**ADDENDUM NO. 1
TO CONTRACT DOCUMENTS FOR THE
LIVE OAK RESTORATION REACH PROJECT
Project No. 91864005 Contract No. C0726
Invitation No. VW0669**

C0726 – LIVE OAK RESTORATION REACH PROJECT

Revised Plans: Sheets G-02, G-03, G-04, G-05, G-06, G-07, G-08, G-09, G-10, G-11, G-12, D-01, D-02, D-03, D-04, D-05, D-06, D-07, V-01, V-02, V-03, V-04, C-01, C-02, C-03, C-04, C-05, C-06, C-07, C-08, C-09, C-10, C-11, C-12, C-13, C-14, C-15, X-01, X-02, X-03, X-04, X-05, X-06, X-07, X-08, and X-09

SCALE AS SHOWN	PROJECT NUMBER: 91864005
VERIFY SCALES	SHEET CODE: G-11
0 1" BAR IS ONE INCH ON ORIGINAL DRAWING IF NOT ONE INCH ON THIS SHEET, ADJUST SCALES ACCORDINGLY	SHEET NUMBER: 11

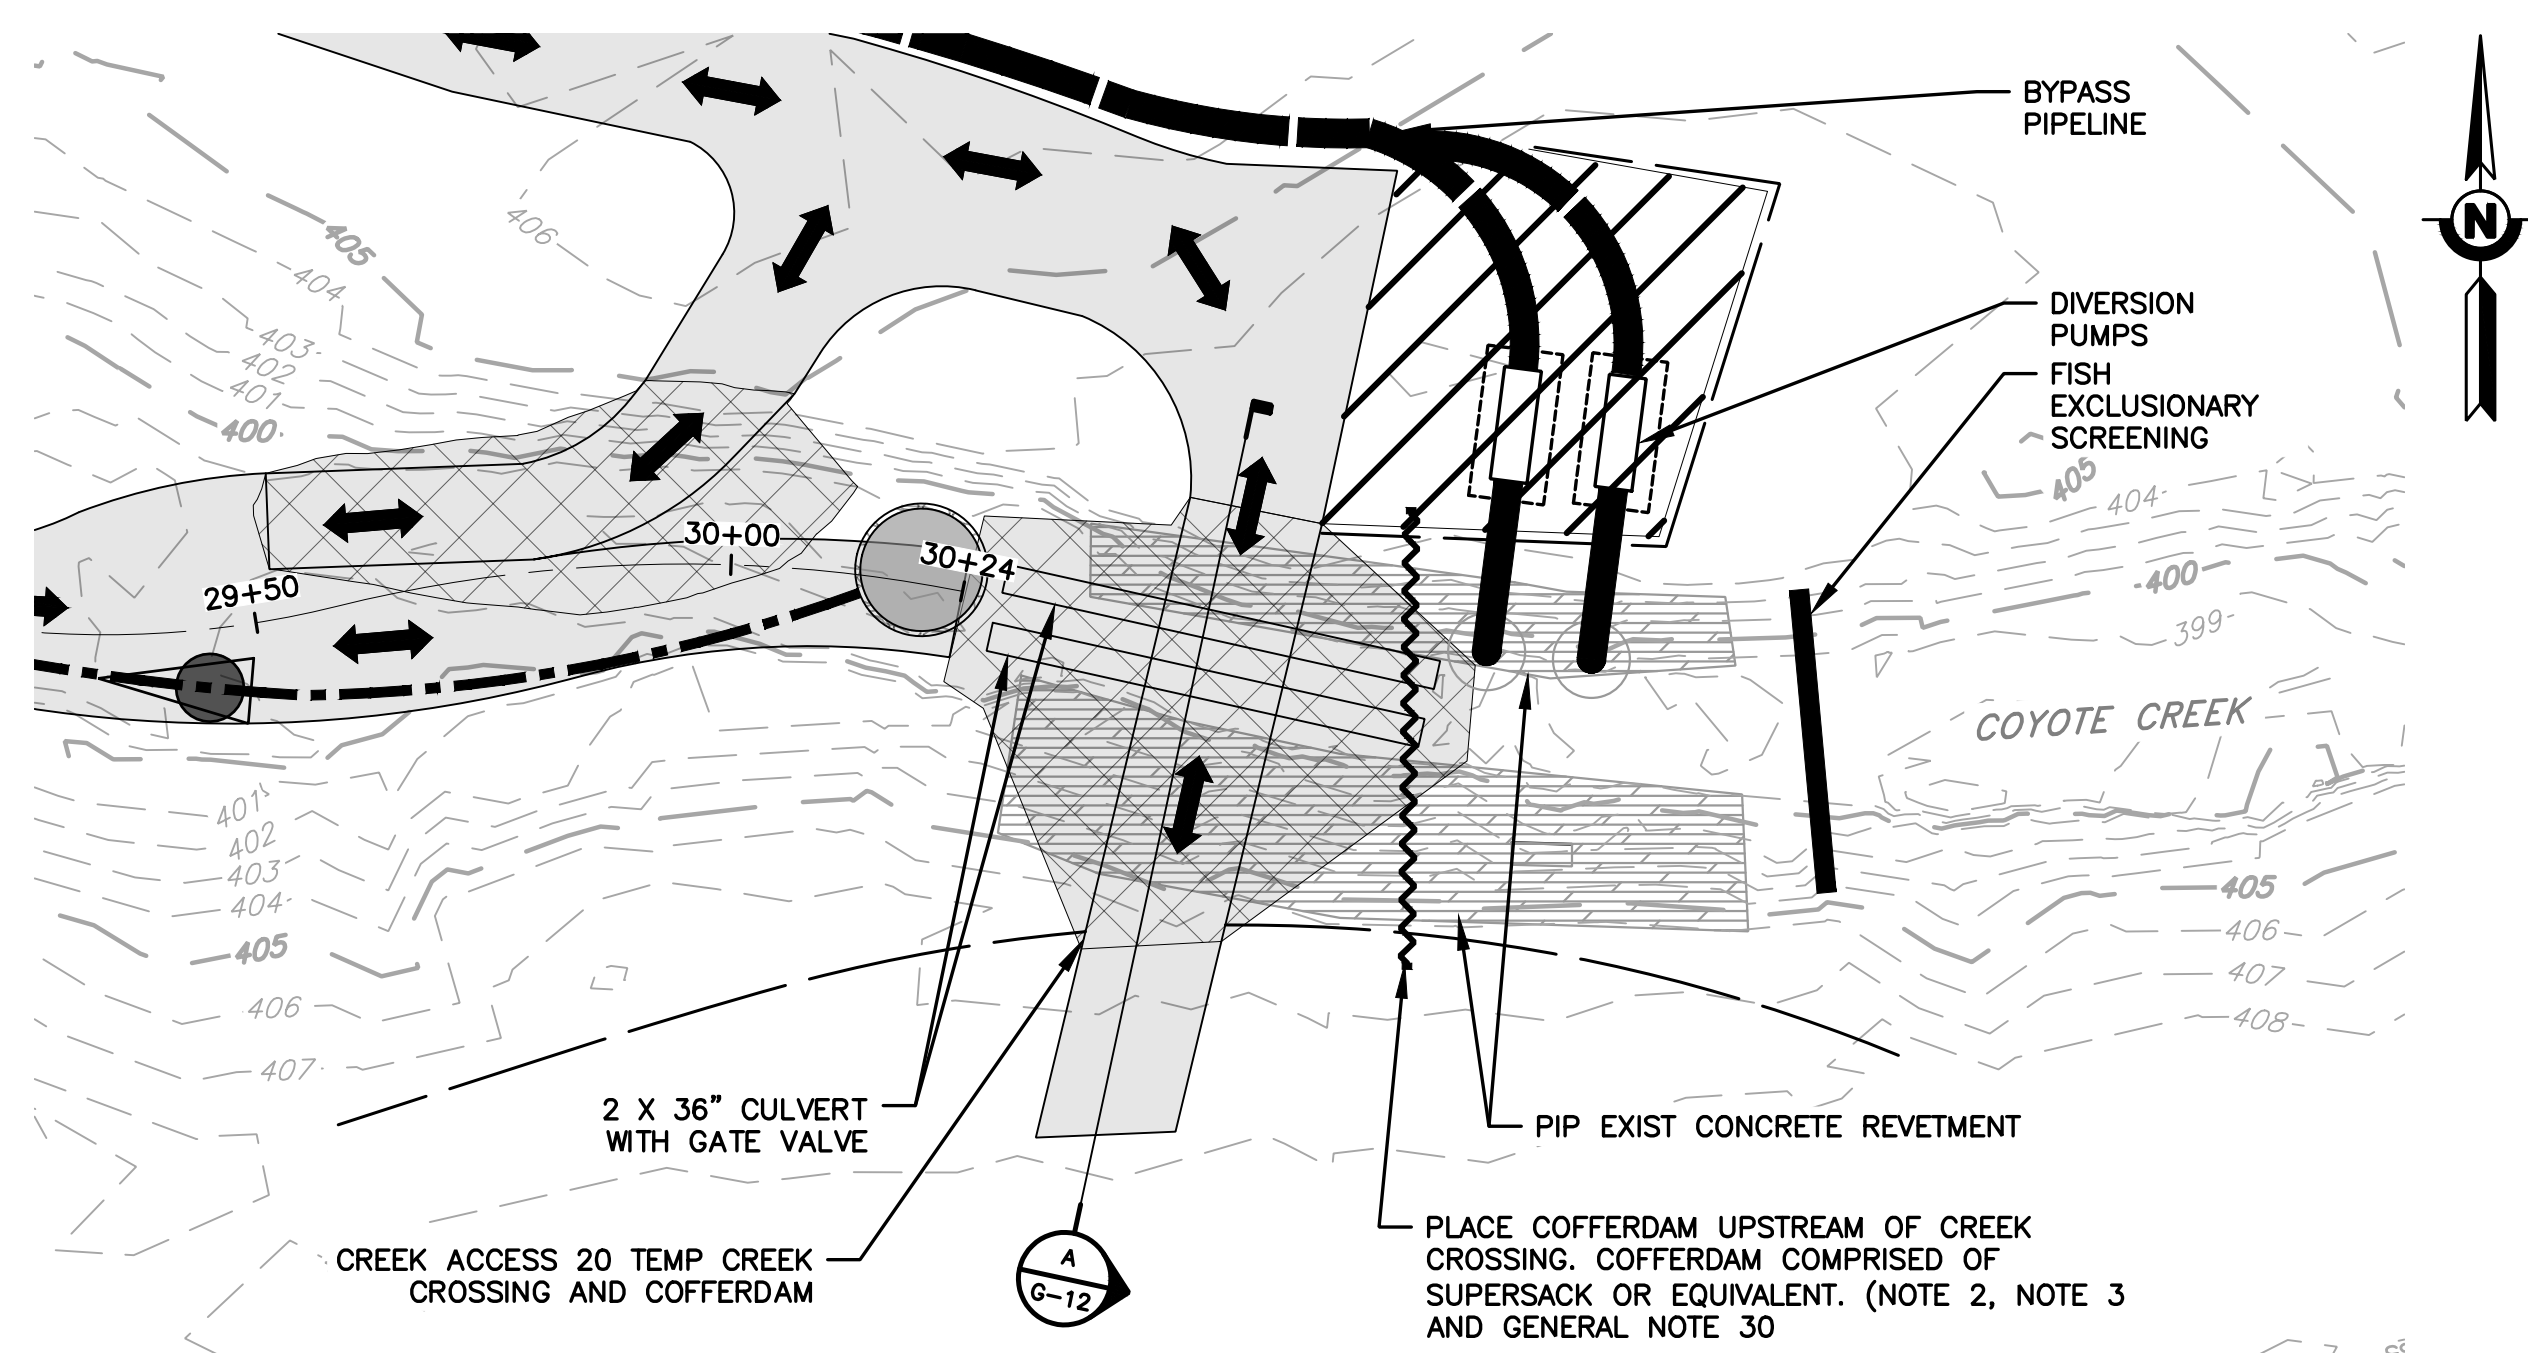
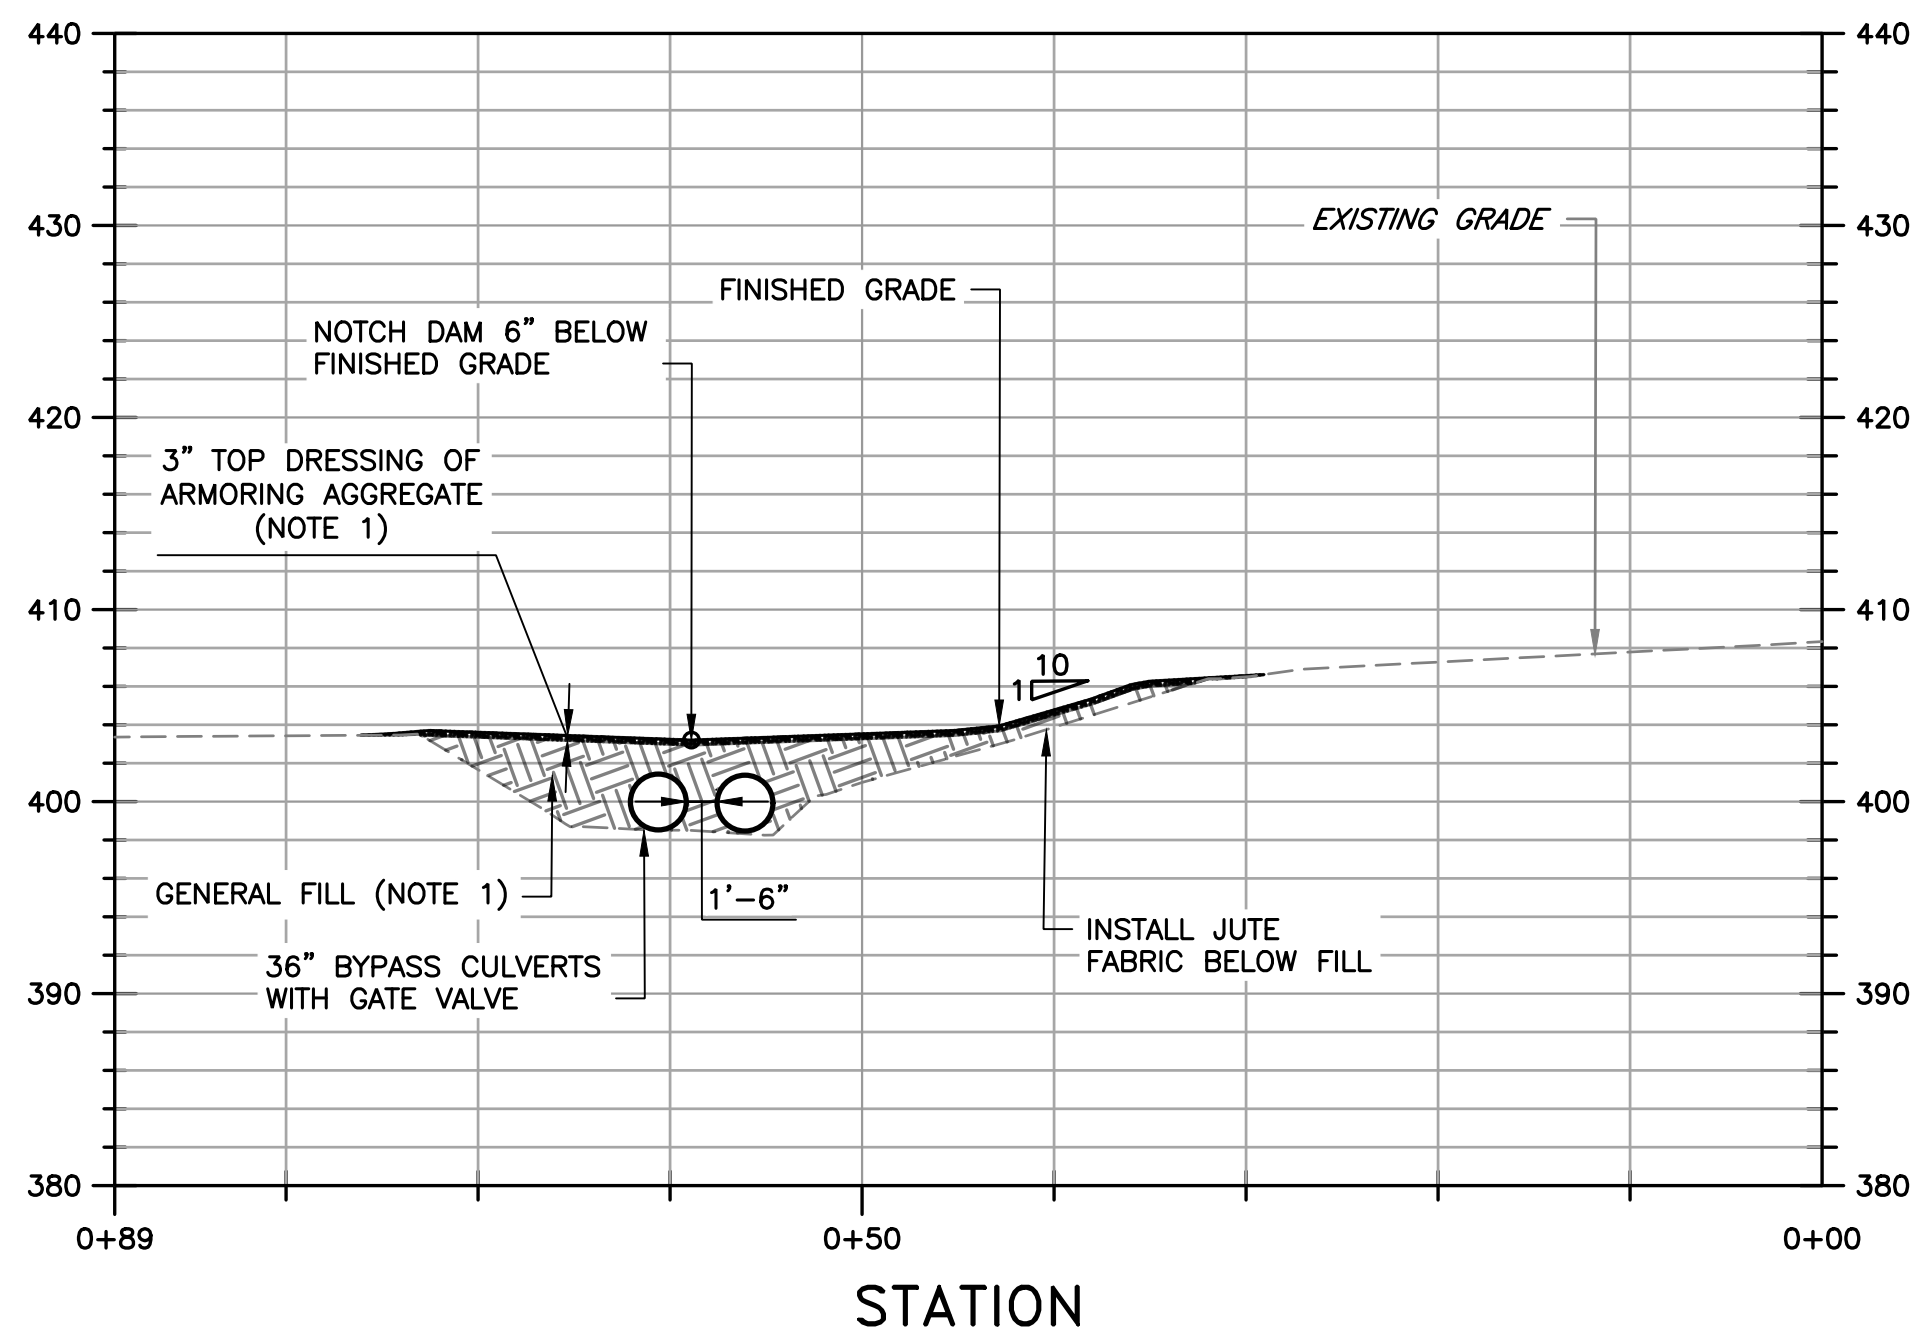
QUESTION 4: (Date Received – April 28, 2026)

Please see Sections on Plan Sheets G-08 through G-12 for installation of Armoring Aggregate.
